Final Subsequent Environmental Impact Report
Ravenswood/Four Corners Transit Oriented Development Specific Plan Update

SCH#: 2022040352

November 2024

FIGURE 2.3-1

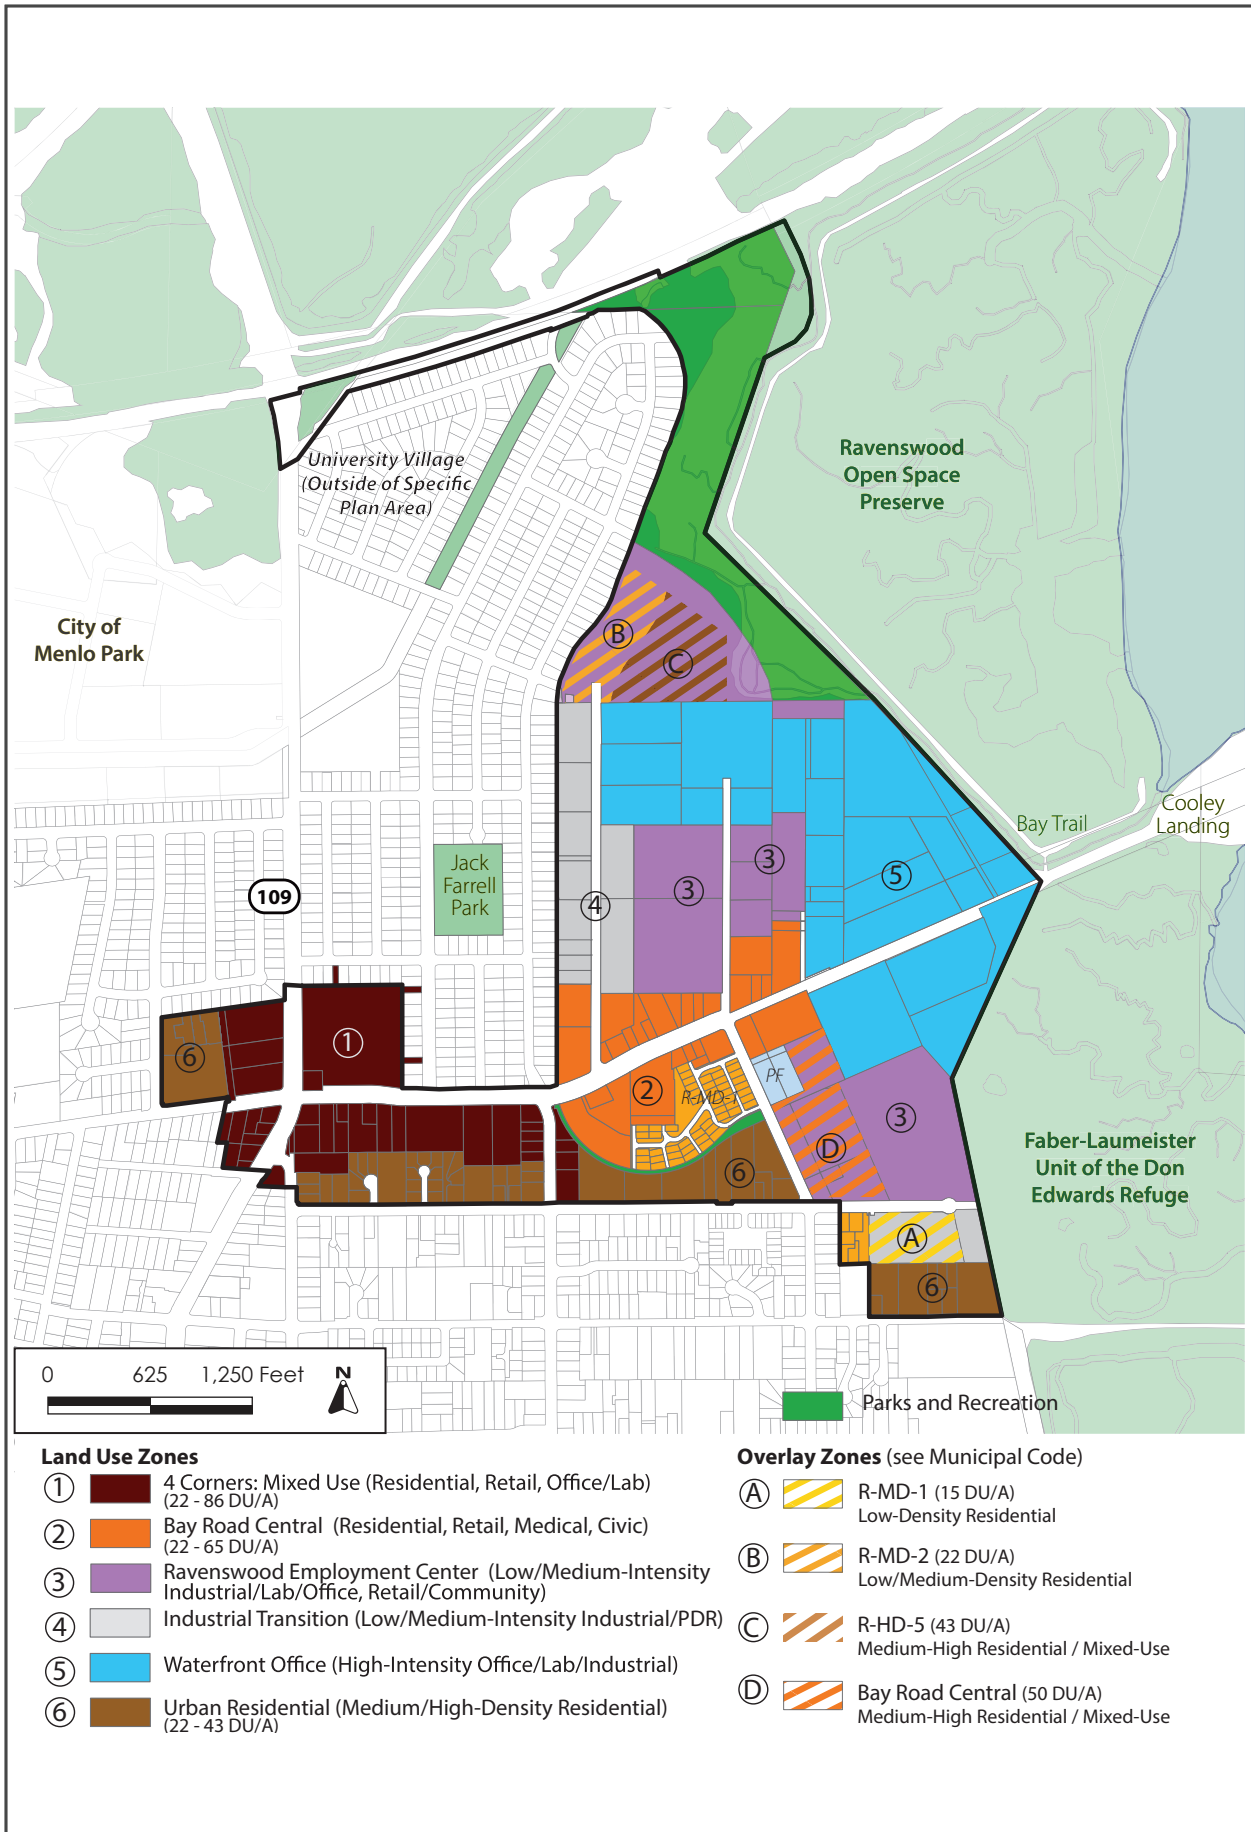
5. Figure 2.3-1 Specific Plan Update Land Use Map - (page 11) - This diagram identifies the site at the end of Tara as part of the Ravenswood Employment Zone when this wants to be Waterfront Office. Not sure what the rational is to now include the east side of Demeter Street as Industrial Transition. West side of Demeter makes sense, but the east side doesn't.

- There is an internal inconsistency between "Urban Residential" as described in the text versus how it is described on Figure 2.3-1. The text lists a maximum density of "40 dwelling units per acre" whereas the figure indicates "43 du/a."

- **Urban Residential (Up to ~~43-40~~ du/ac; Medium/High-Density Residential).** Intended to provide opportunities for the development of a variety of housing types at moderate densities. Accommodates single-family attached residential units)and multi-family apartments or condominiums.

Page 11: **REPLACE** Figure 2.3-1 Ravenswood/4 Corners TOD Specific Plan Update Land Use Map with the following Figure 2.3-1 Ravenswood/4 Corners Specific Plan Update Land Use Map which includes a correction to the residential density in the Four Corners area and the correction to the name of the wetland area adjacent to the southeast portion of the Plan area:

FIGURE 2.3-2

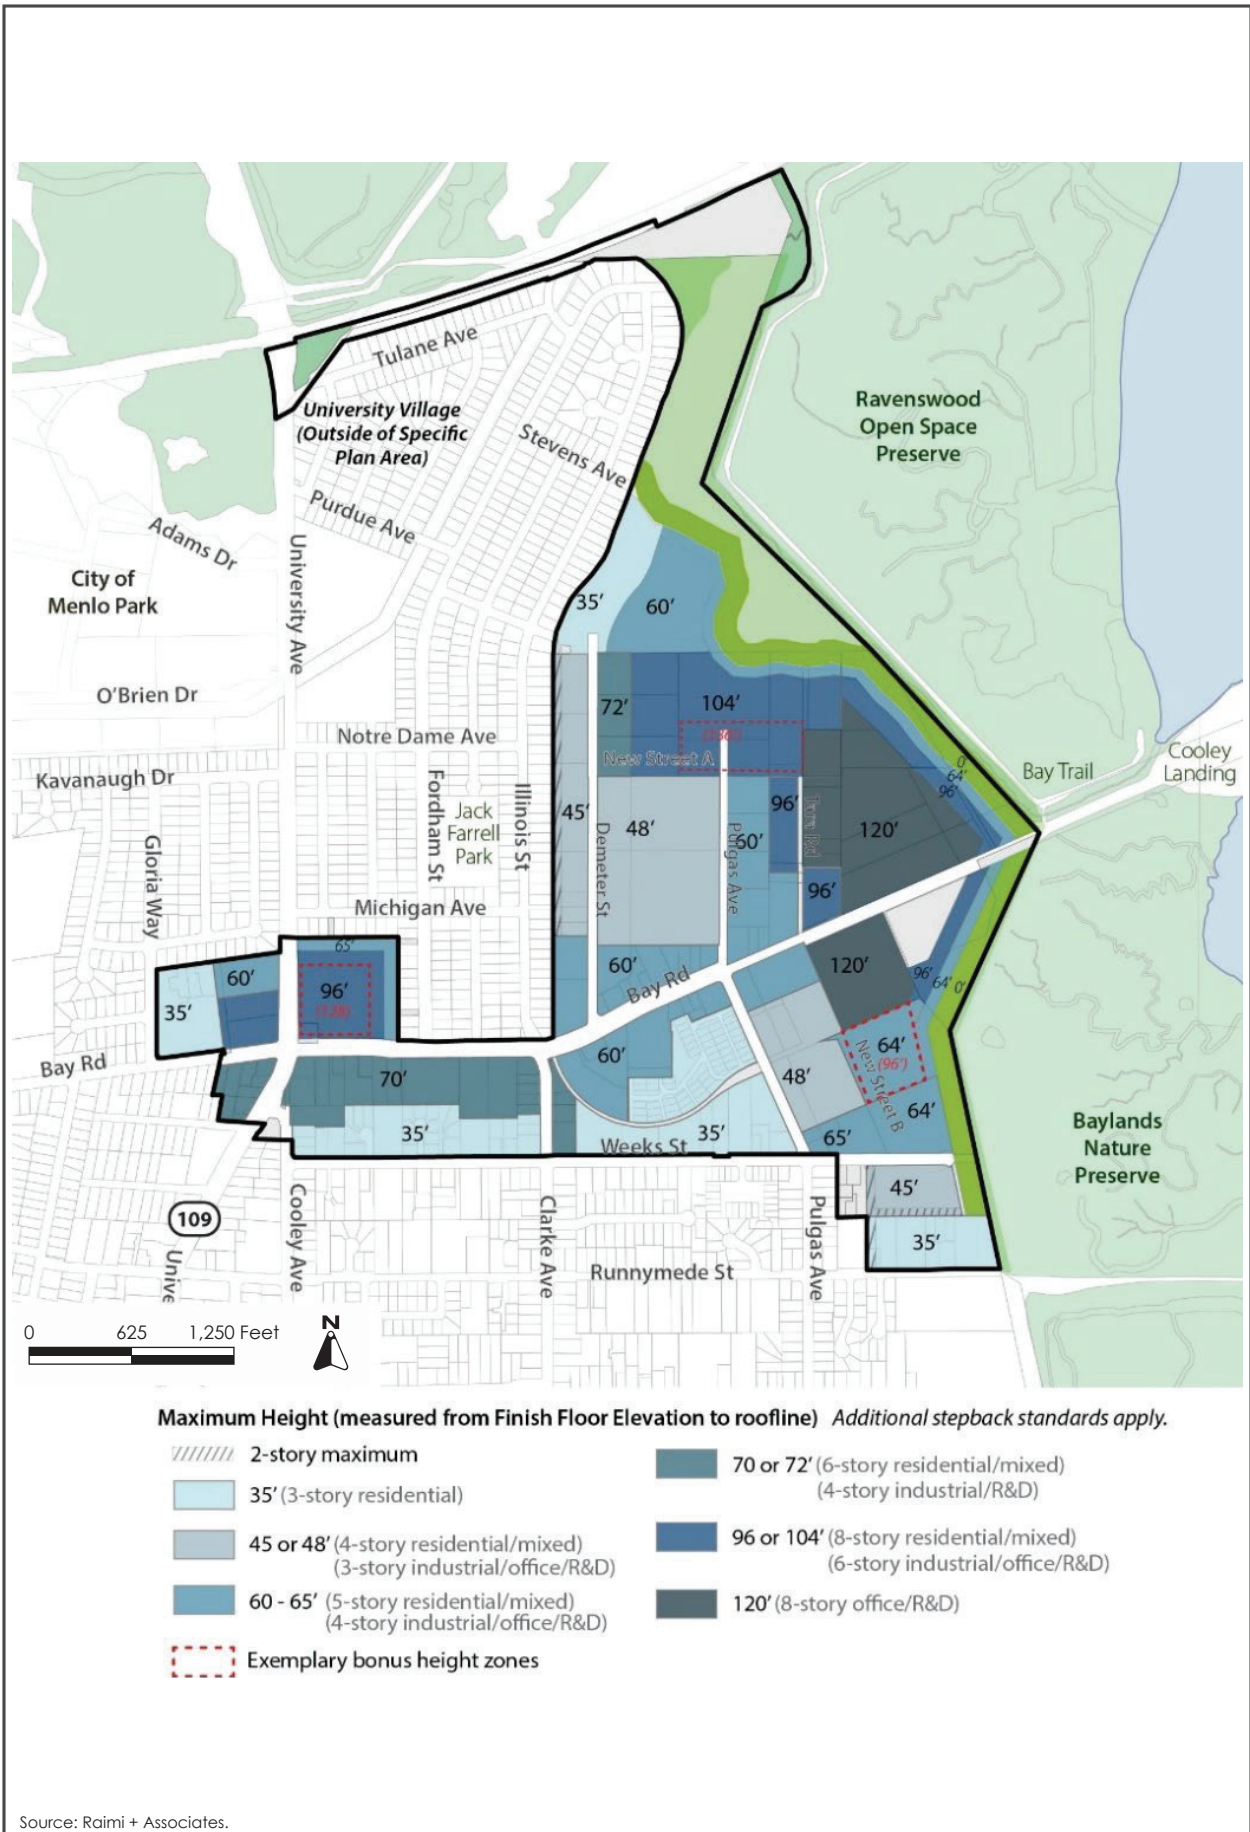
The analysis at page 49 discusses a maximum building height of 120 feet whereas elsewhere (Figure 2.3-2) the DSEIR discusses a maximum building height of 122 feet. The document should be internally consistent, and the impact analyses should be based on a consistent maximum building height.

Response V.12: Refer to Response K.31. A previous version of the Specific Plan Update showed the maximum building height allowed for future developments in the Specific Plan area would be 122 feet above the ground surface. However, Specific Plan Update Figure 4-5 has been revised and shows the maximum building height allowed under the Specific Plan Update is 120 feet above the ground surface. Draft SEIR Page 14 in Section 2.0 Project Information and Description states the maximum building heights under the Specific Plan Update would range from approximately 30 feet to 122 feet above the ground surface, which reflects the maximum height that was previously proposed. The referenced height of 122 feet has been revised on Page 14 to 120 feet. The remainder of the Draft SEIR text references the 120-foot maximum height. The Draft SEIR Page 16, Figure 2.3-2 Maximum Building Heights has been revised to be consistent with Figure 4-5 in the Specific Plan Update. Refer to Section 5.0 Draft SEIR Text Revisions in the Final SEIR.

Page 16 **REPLACE** Figure 2.3-2 Maximum Building Heights with the Specific Plan Update figure that shows the maximum building height of 120 feet instead of 122 feet:

FIGURE 2.3-3

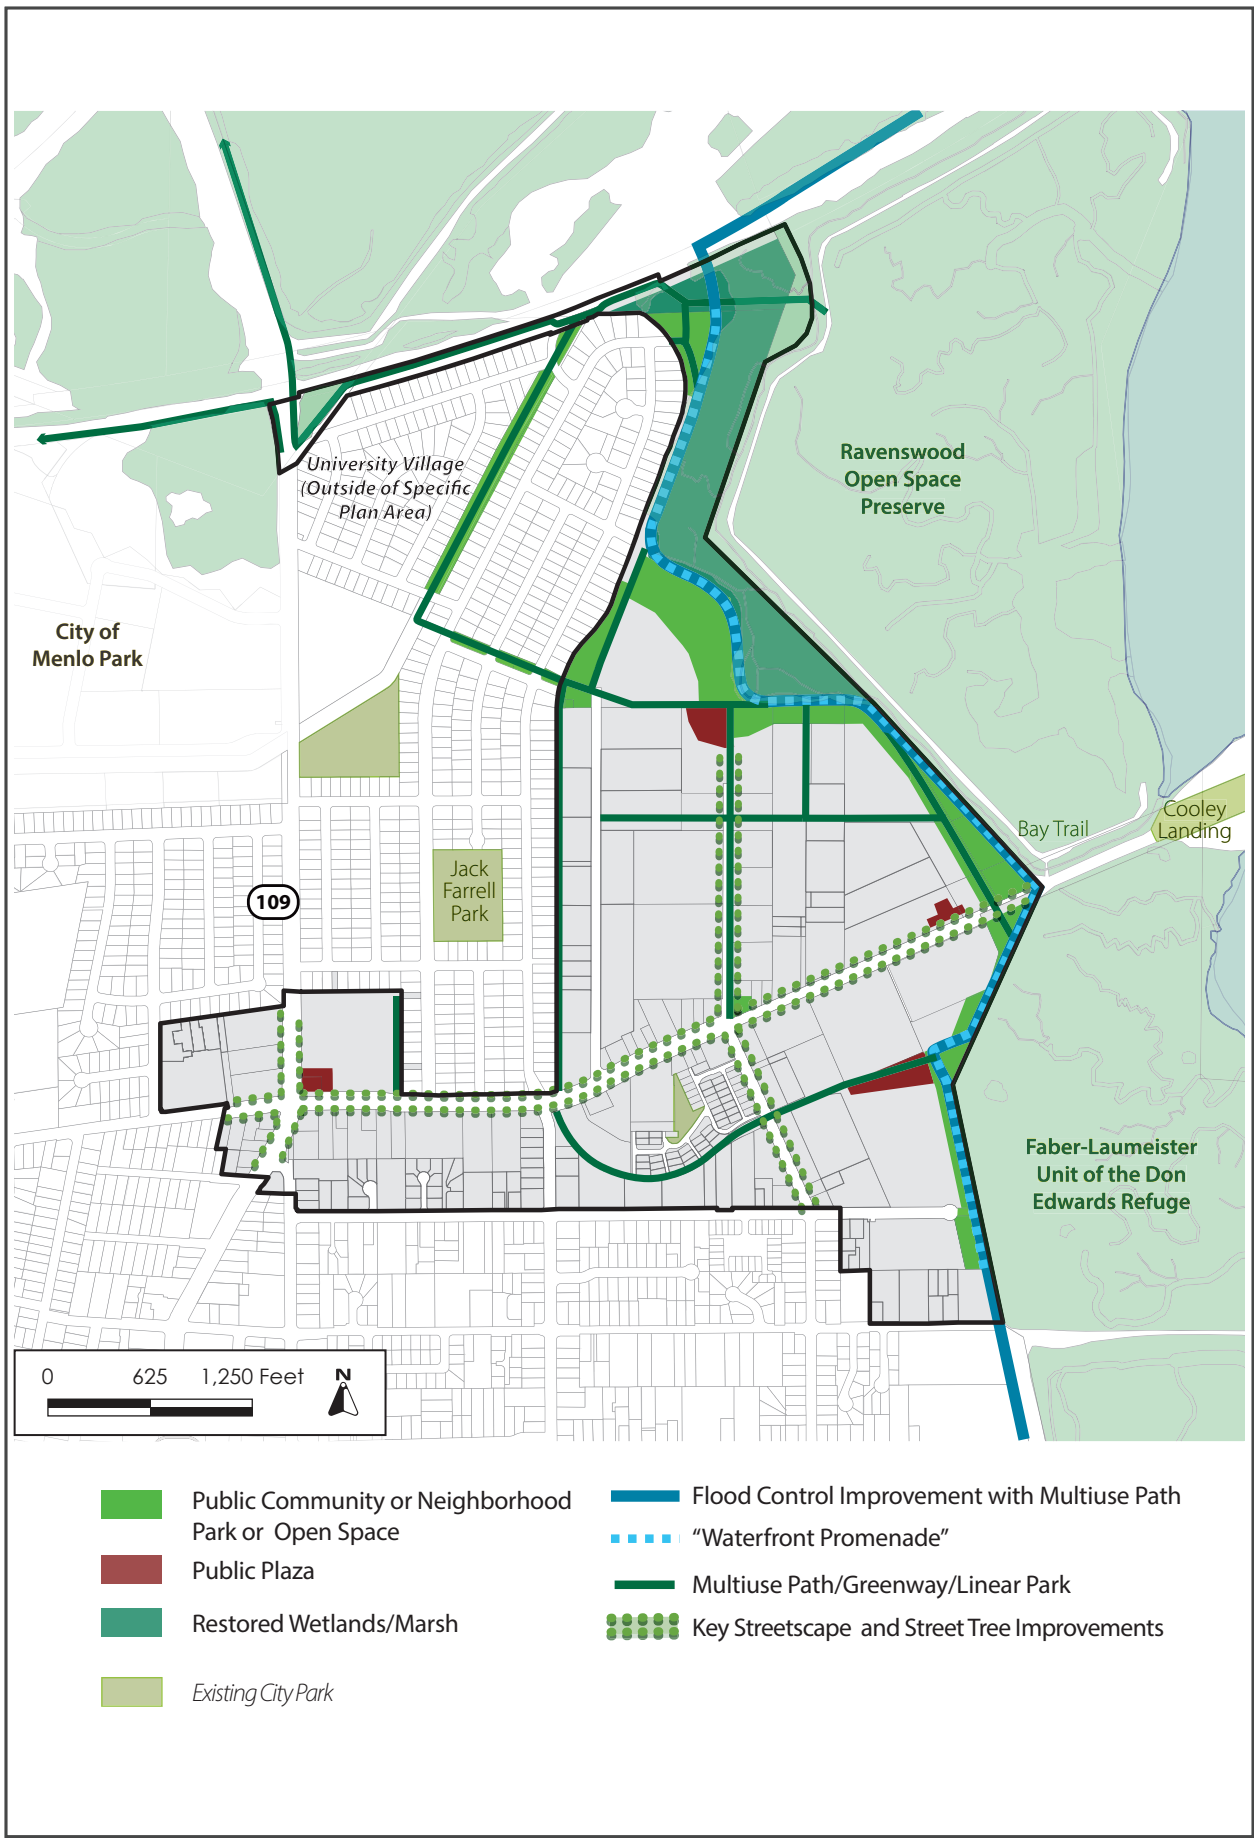
Comment V.8: Figure 2.3-3 (p. 17) indicates an exact location for a publicly accessible plaza on the Four Corners site, but the property owner has not agreed to that location. Sand Hill’s comments on the Specific Plan requested that this issue be resolved. There should not be small, precise rectangles indicating open space at Four Corners.

Response V.8: The above comment raises concerns about features in the Specific Plan Update itself, such as the publicly accessible plaza on Draft SEIR Page 17 Figure 2.3-3, an internal street and an access street with pedestrian/bicycle facility on Draft SEIR Page 20, Figure 2.3-4, and not the Draft SEIR’s analysis of the Specific Plan Update. The figures have been revised based on the above recommendations. Refer Section 5.0 Draft SEIR Text Revisions of this Final SEIR. .

Page 17: **REPLACE** Figure 2.3-3 Open Space Network Diagram with the following Figure 2.3-3 that shows revisions to the conceptual public plaza in the Four Corners area:

FIGURE 2.3-4

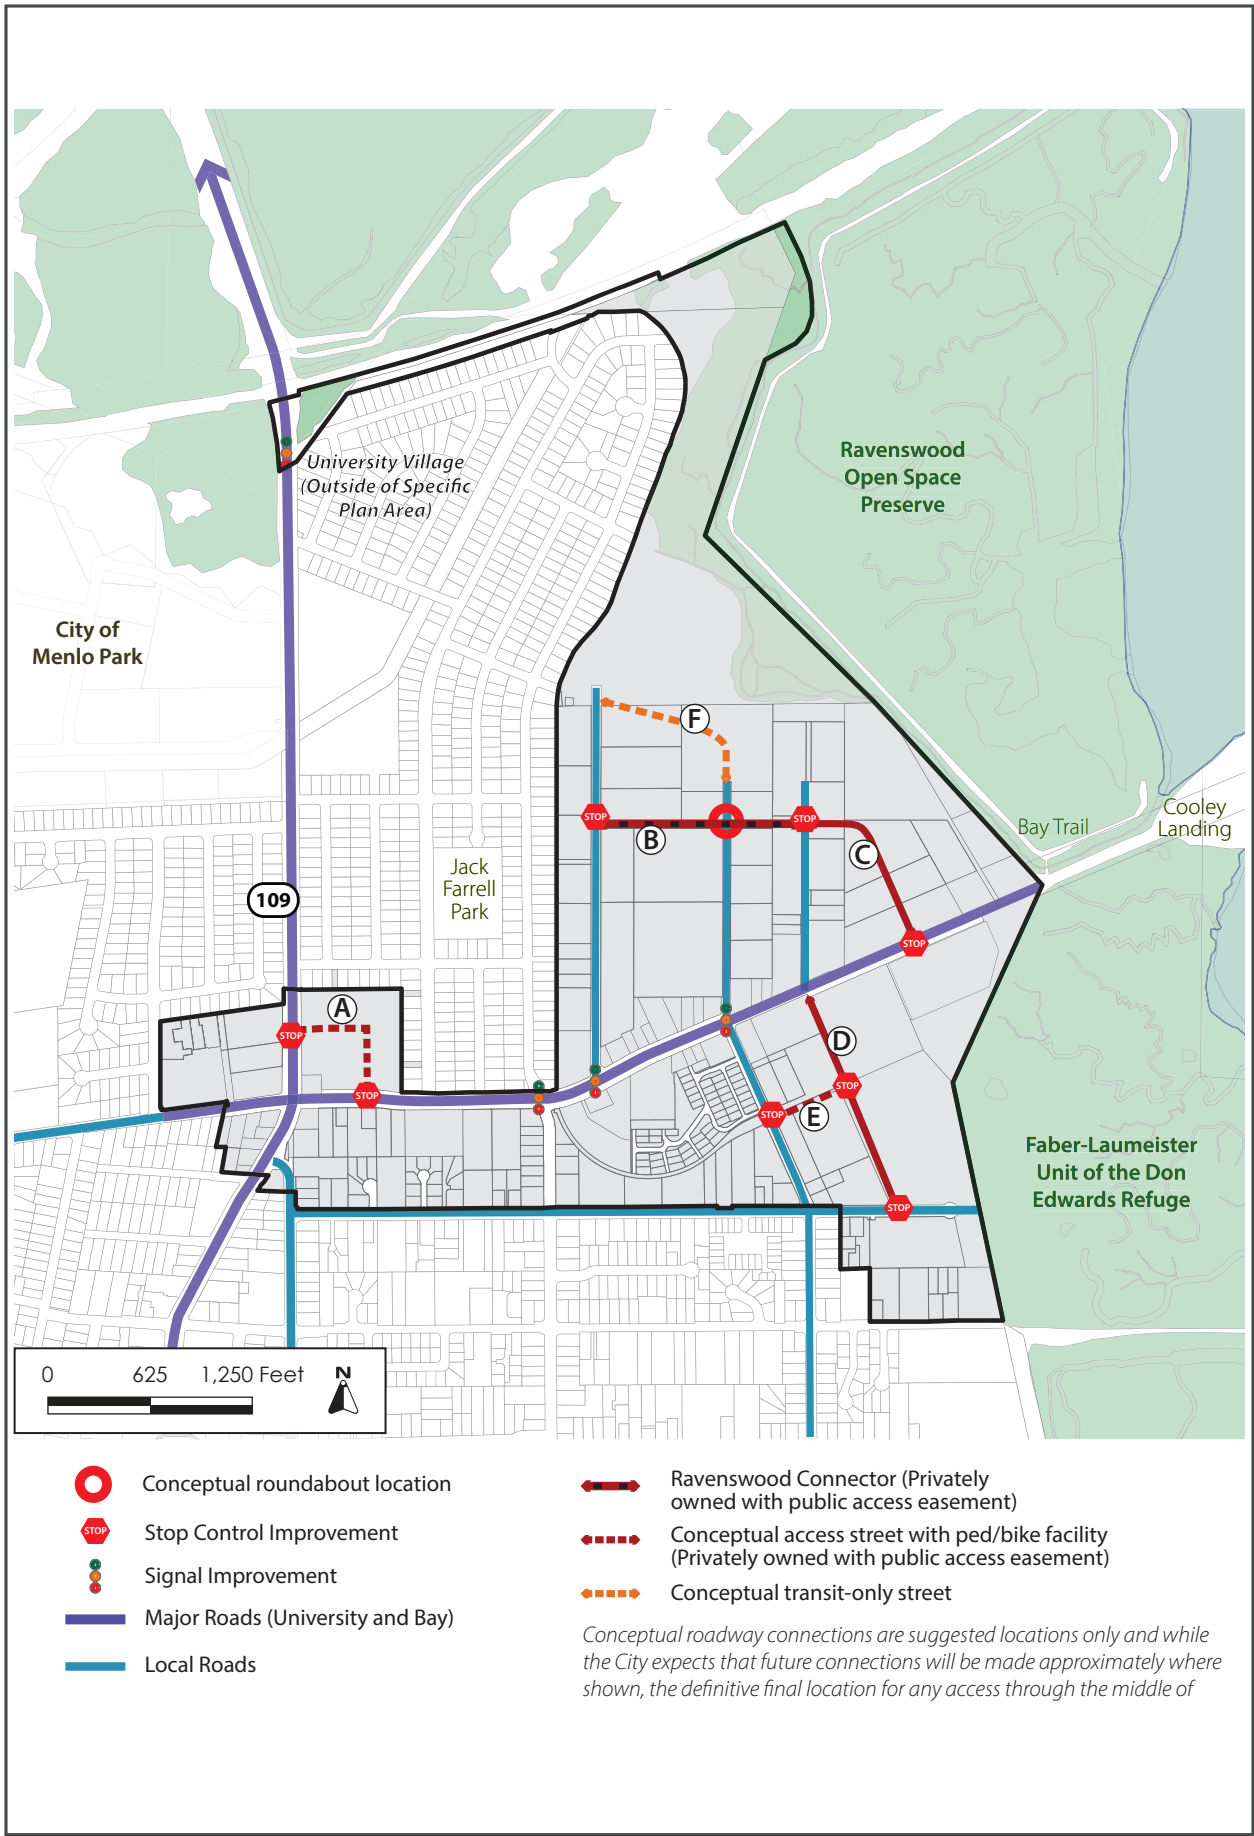
Section 2.3.5.1 describes the public roadway network and loop road. It references “an internal street at Four Corners (see Figure 2.3-4), between University Ave and Bay Rd.” See p. 18. Similarly, Figure 2.3-4 Roadway Network and Improvements shows “Access Street with Ped/Bike Facility (Privately owned with public access easement).” Sand Hill’s comments on the Specific Plan requested that any requirement to dedicate a public access easement across private property at Four Corners be removed. Converting privately owned land to public use without just compensation would create a taking. (Similar changes are required to the Transportation Analysis.)

- Figure 2.3-4
The legend of this map does not explain the meaning of the letters A to F seen on the map.
- Section 3.10
In the last line of the discussion of Flood Hazard Existing Conditions, the text on page 235 refers the reader to a Non-CEQA discussion in “Section 3.10.3”. There is no such section. We believe the intended reference is 3.11.3.

Response W.6: The Public Roadway Network shown on Draft SEIR Figure 2.3-4 (Page 20) is described on Draft SEIR Page 18. The associated letters shown on Figure 2.3-4 have been added to the roadway network description on Page 18 for clarification. Refer to Section 5.0 Draft SEIR Text Revisions in this Final SEIR.

Page 20: **REPLACE** Figure 2.3-4 Public Roadway Network and Improvements with the following Figure 2.3-4 Roadway Network and Improvements which includes which shows the access street through the Four Corners area is conceptual:
